# MICROCHIP PIC18F2420/2520/4420/4520

## PIC18F2420/2520/4420/4520 Rev. B2 Silicon Errata

The PIC18F2420/2520/4420/4520 Rev. B2 parts you have received conform functionally to the Device Data Sheet (DS39631C), except for the anomalies described below. Any Data Sheet Clarification issues related to the PIC18F2420/2520/4420/4520 will be reported in a separate Data Sheet errata. Please check the Microchip web site for any existing issues.

**FIGURE 1: SCK PULSE VARIATION USING TIMER2/2**

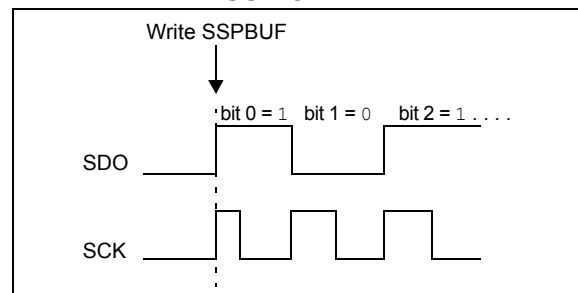
When the SPI is using Timer2/2 as the clock source, a shorter than expected SCK pulse may occur on the first bit of the transmitted/received data (Figure 1).

To avoid producing the short pulse, turn off Timer2 and clear the TMR2 register, load the SSPBUF with the data to transmit and then turn Timer2 back on. Refer to Example 2 for sample code.
